ALERT SERVICE BULLETIN

SUBJECT: NAVIGATION - Attitude and Heading Reference System (AHRS)

**Modification of the wiring of the FLIGHT/GROUND logic
(connector 11 ALPHA)**

Corresponds to modifications 365A084754.00 and 365A084754.01

Figure 1

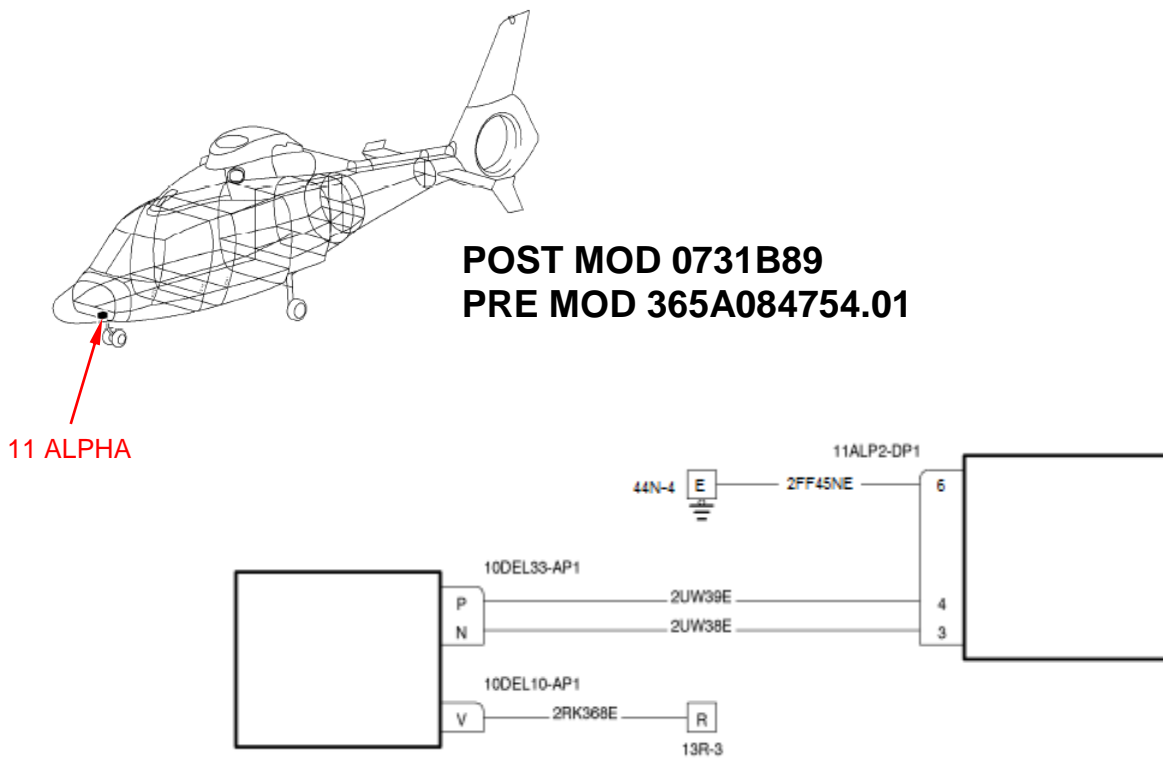
- Perform the modification of the connection to connector 11 ALPHA as per [Figure 1](#).

PRE MOD 365A084754.00

11ALP2-CP1	
VOL 1	1	1UW22E	
	2	1UW25NE	
	5	1FF4E	
VOL 5	6	1FF45NE	
	7	1UW28E	
VOL 7	8	1UW29E	
		11ALP2-DP1	
VOL 2	1	2UW22E	
	2	2UW25NE	
VOL 6	5	2FF4E	
	6	2FF45NE

POST MOD 365A084754.00

11ALP2-CP1	
VOL 5	5	1UW22E	
	6	1UW25NE	
VOL 7	7	1FF4E	
	8	1FF45NE	
VOL 1	1	1UW28E	
	2	1UW29E	
		11ALP2-DP1	
VOL 6	5	2UW22E	
	6	2UW25NE	
VOL 2	1	2FF4E	
	2	2FF45NE

Figure 2

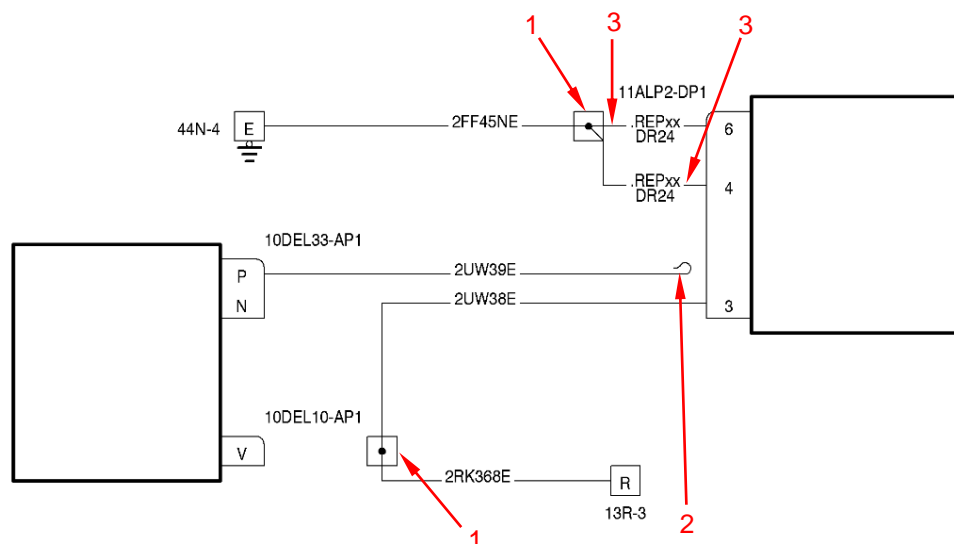
- Perform the modification of the connection to connector 11 ALPHA as per [Figure 1](#).
- Perform the modification of the wiring to connector 11 ALPHA as per [Figure 2](#).

**POST MOD 0731B89
POST MOD 365A084754.01**
